NORWICH TO TILBURY PROPOSAL

INTERESTED PARTY REFERENCE NUMBER: [REDACTED] (VILLAGES AGAINST PYLONS)

This is a supplemental submission made in response to **Document: 8.4.8 Applicant's Comments on any Further Information or Submissions Received by Deadline 2**, to **Document: 8.4.1.2 Addendum to Applicant's Comments on Relevant Representations - Part 2** and to the proceedings on Day 2 of **Issue Specific Hearing 2**. We also address **Action Point 30 'Dedham Vale 2'** with respect to that hearing.

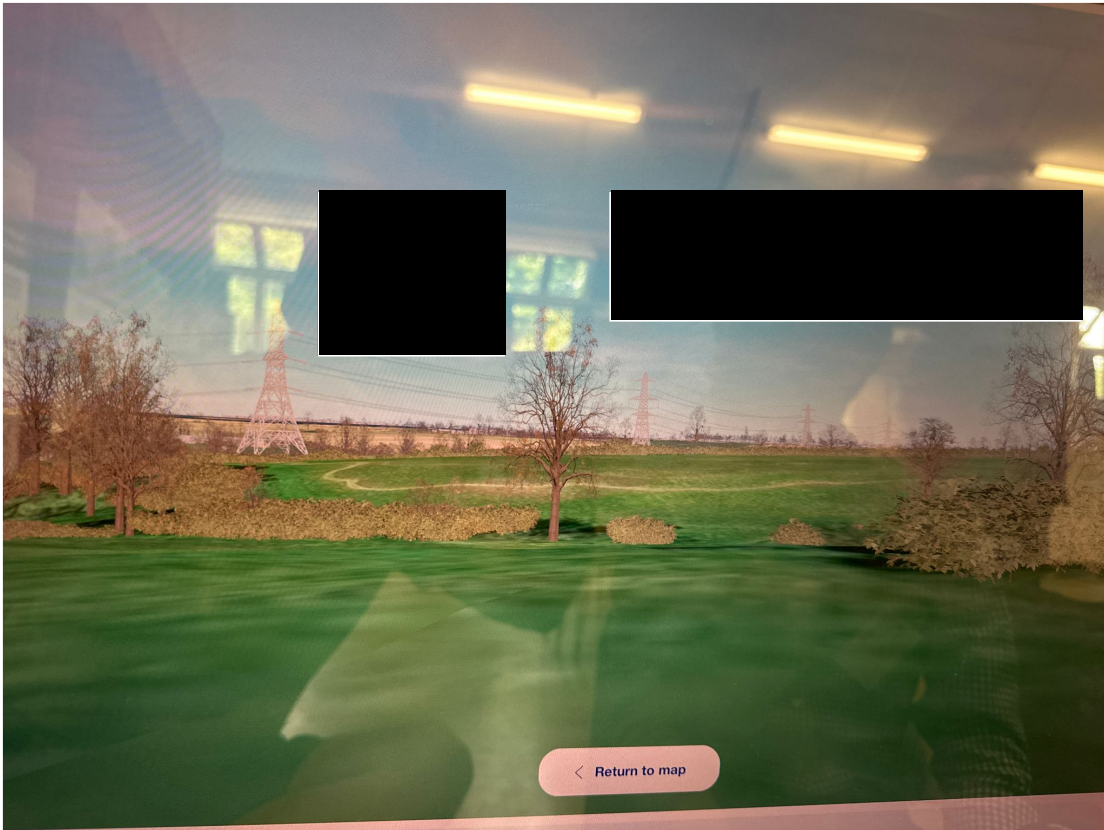
We fully support and echo the submission at ISH2 made by Fordham Parish Council: the proposals would entirely destroy the visual impact of the far reaching views within the Colne Valley and in particular from the Essex Way, which is one of the foremost footpaths in the Country.

Although not within a National Landscape, the essential quality of this valley is not significantly different to that of the best parts of the Dedham Vale and it is worthy of protection. There is nothing within National Policy which prohibits undergrounding here and indeed it is recognised that in special locations and when impact is far reaching, which surely it is in this case due to the views of the valley visible from Colchester and due to the presence of the Essex Way and the high footfall there, undergrounding can still be appropriate.

Views from Coney Byes Farm, rear garden, across valley.

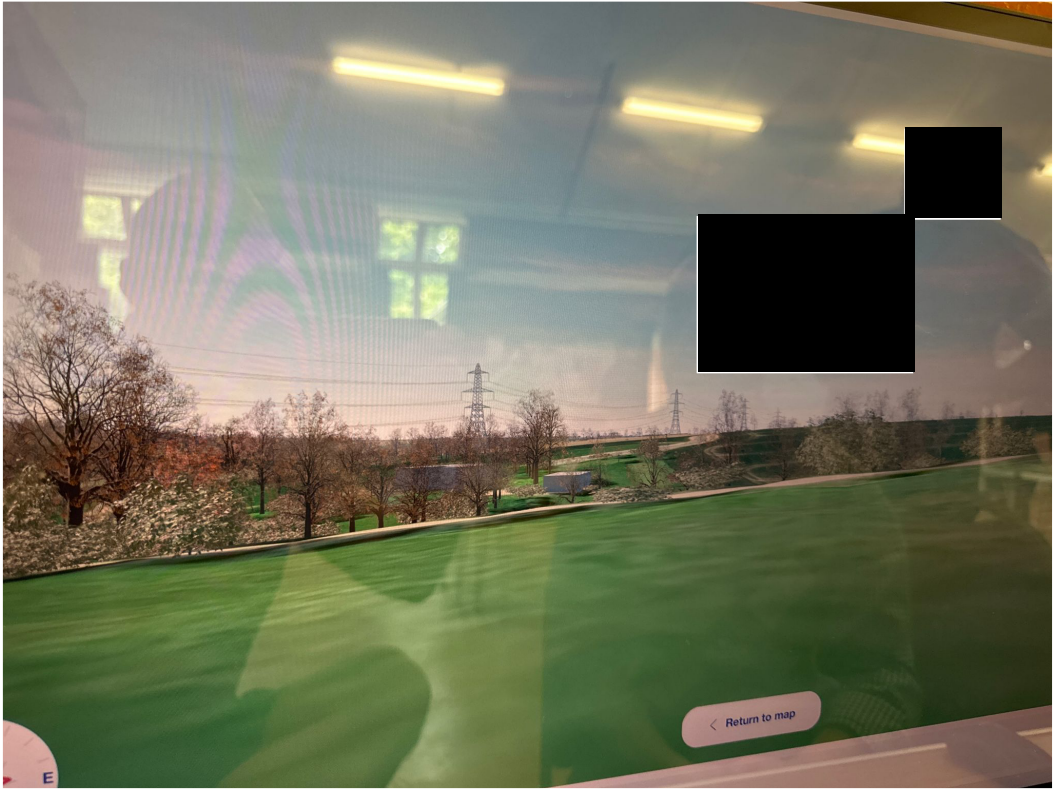
It is remarkable that National Grid failed to identify harm and have included no relevant viewpoints in respect of these important listed buildings at the top of the Colne Valley, closest to the Dedham Vale for your consideration.

At one of their open events, we were provided with visualisations from some of these locations which we have included below. The impacts are, as you can see, devastating. We apologise for the quality of these graphics: whilst we were allowed to take photographs, we were not provided with high quality downloads.

In order to mitigate the harm, the undergrounding section which commences at Great Horkesley should be extended through the Colne Valley to a point beyond Aldham, which would serve both to protect this valley and to substantially eliminate harm to the Dedham Vale (in the event that the latter is not 'avoided entirely').
